ACF Charting Forum

Step-Down Fix Issue/Note

Step-Down Fix Chart Notation Issue

Step Down Fix example

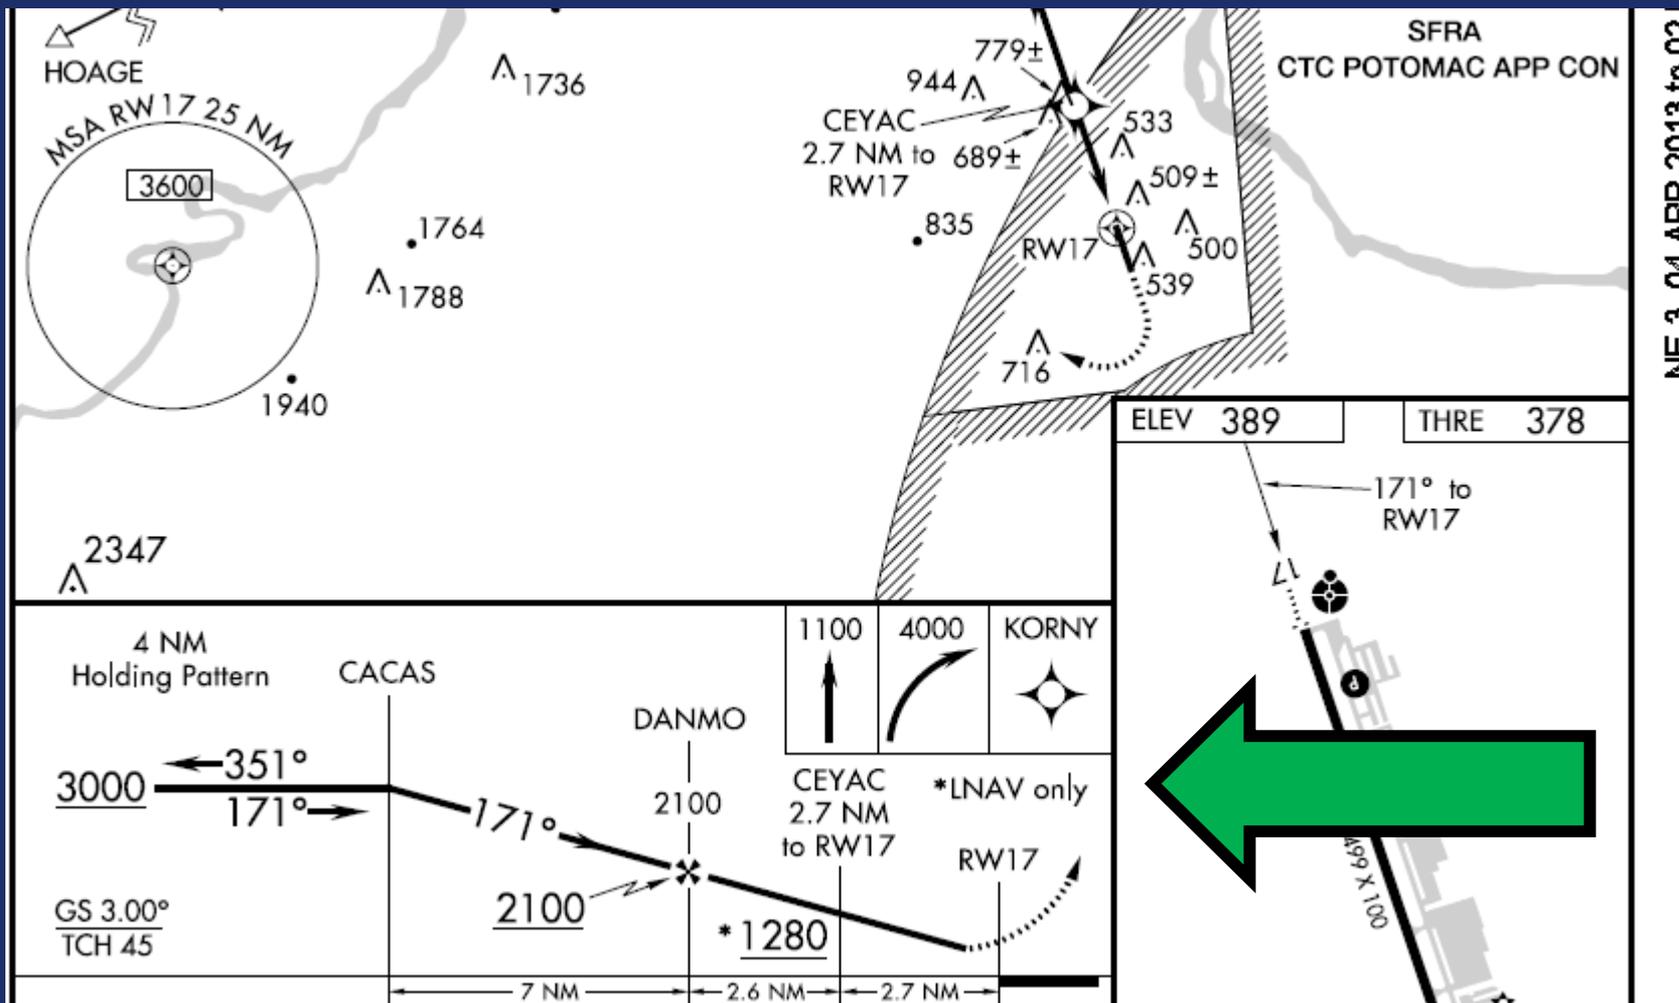
- **Profile view chart notation (*LNAV only) implies step-down fixes only apply to LNAV line of minima.**
 - This can be misinterpreted by aircrew and some procedure designers as not applicable to LNAV/VNAV.

Profile view at CEYAC states

*LNAV Only

- **Operators/pilots are increasingly treating baro-VNAV vertical guidance as equivalent to ILS.**
 - Increasing aircraft automation, displays (looks like a duck, quacks like a duck).
 - “New” RNAV(GPS) LNAV/VNAV minima.
 - Baro-VNAV previously used only for “advisory” purposes.
 - Losing awareness of AFM(S) limitation.
 - Chart note implies step-down fix does not apply to LNAV/VNAV (*LNAV only).

- **Change step-down fix note to:**

“ *N/A LPV ”

- Clearly states the step-down fix is not applicable to LPV.
 - Removes any doubt that step-down fix does apply to both LNAV and LNAV/VNAV.
 - No complicated segregation for SBAS vertical guidance versus baro-VNAV guidance.
- Reinforces baro-VNAV AFM(S) limitation (as intended) to use barometric altimeter as an operational mitigation.
- No other charting or criteria change needed.
